County of Los Alamos

Parks and Recreation Board

Brewer Arena Improvements

Parks and Recreation Board
November 13, 2025

Grandstand & Pavilion Changes

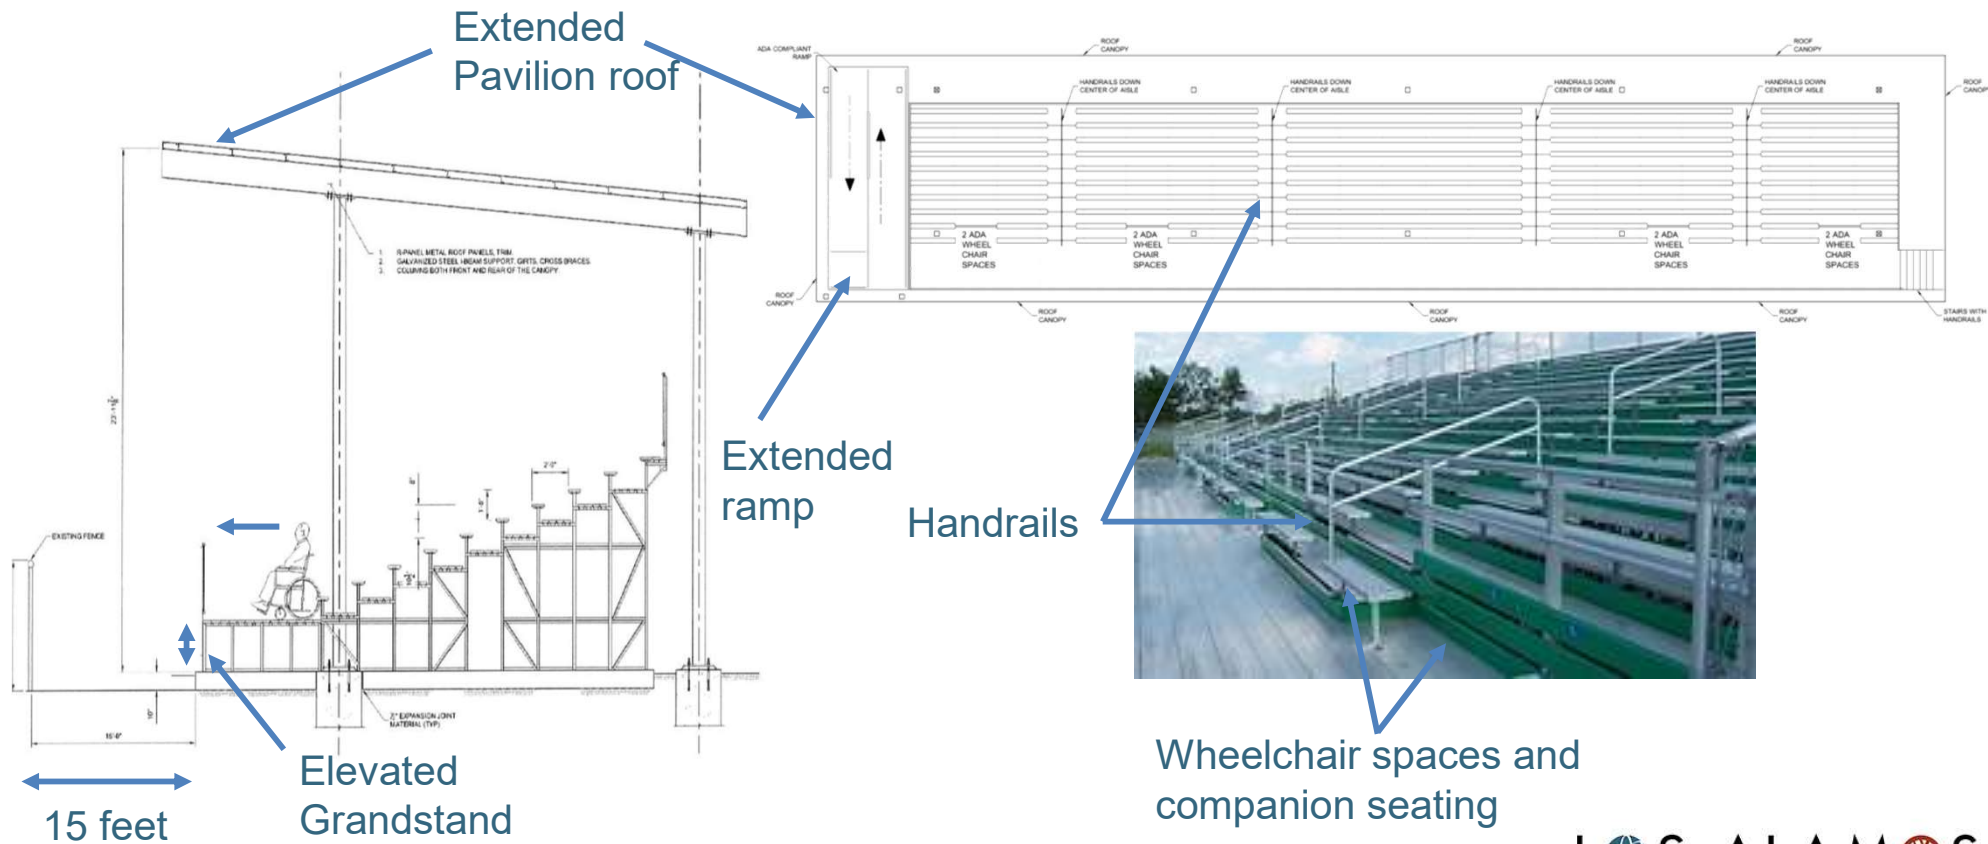
- Adjust elevation so that first row has unobstructed view over arena fence)
- Center the seating on the “50-Yard Line”
- Grandstand to be 15’ away from arena fencing (per PRCA)
 - West side arena access gates need to be unobstructed
- Make seating steps shallower/less steep and with handrails
- Extend the pavilion to provide cover for the entire seating, access ramp, and walkway.

- Increase Grandstand elevation
 - Extend ADA Ramp
- Center Grandstand on the 50-yard line
- Place Grandstand 15’ from arena fence
 - Ensure access gates unobstructed
- Seating incline meets standards
- Enlarge Pavilion

ADA Parking

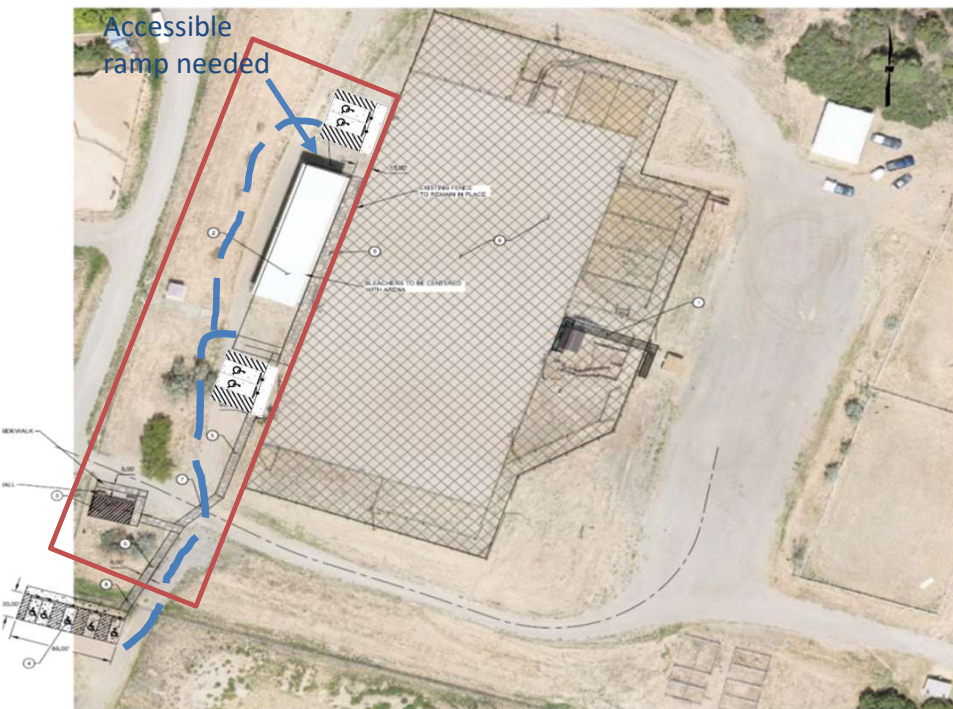
Investigate ADA parking on the north and south of the seating area

- Pros
 - Create a parking that is closer to the grandstand
 - Potentially reduce sidewalk area
- Cons
 - Pedestrian/traffic conflicts
 - Connectors between Grandstand and restroom still needed
 - Vehicle/equestrian flow interference
 - Additional site work required
 - Additional cost
- Recommendation
 - Keep ADA parking on the southside and utilize horse friendly materials on walkway

Restrooms

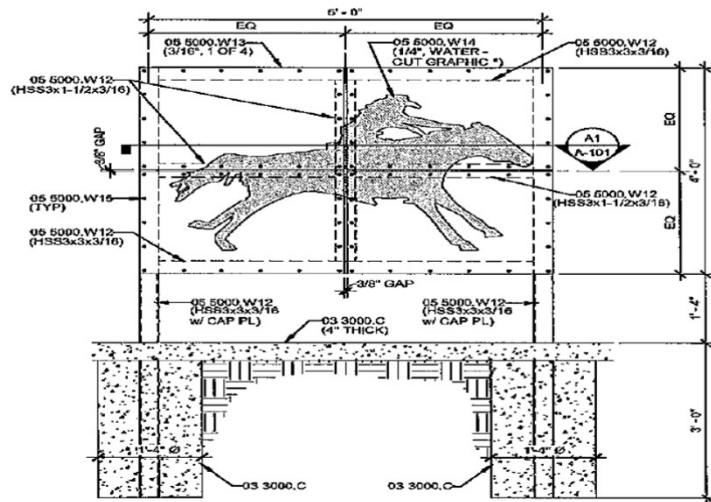
- Sink placement does not allow turnaround wheelchair access
- Restroom capacity will not satisfy the full demand

- Restroom upgrades meet ADA requirements as designed
- Restroom capacity can be increased through the placement of temporary facilities when needed
